# UNITED STATES PATENT AND TRADEMARK OFFICE

APPLICATION NO.	FILING DATE	FIRST NAMED INVENTOR	ATTORNEY DOCKET NO.	CONFIRMATION NO.
10/628,749	07/28/2003	Philip G. Wessells	20003-7003	4857

## Office Action Summary

## **DETAILED ACTION**

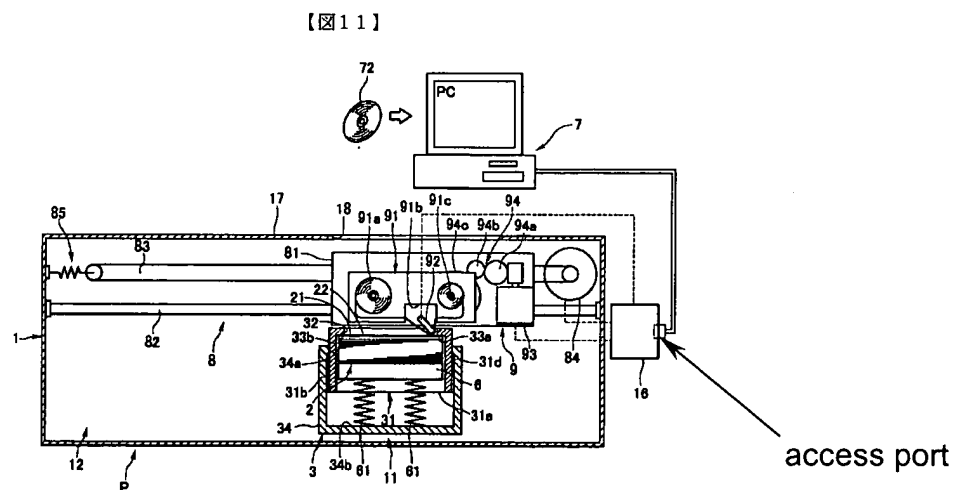
With respect to claim 35, Oikawa et al. discloses the claimed apparatus as mentioned in the above rejection of claim 20 and further discloses an access port in communication with transfer engine 92 as shown in below in the Figure 11 taken from Oikawa et al.:
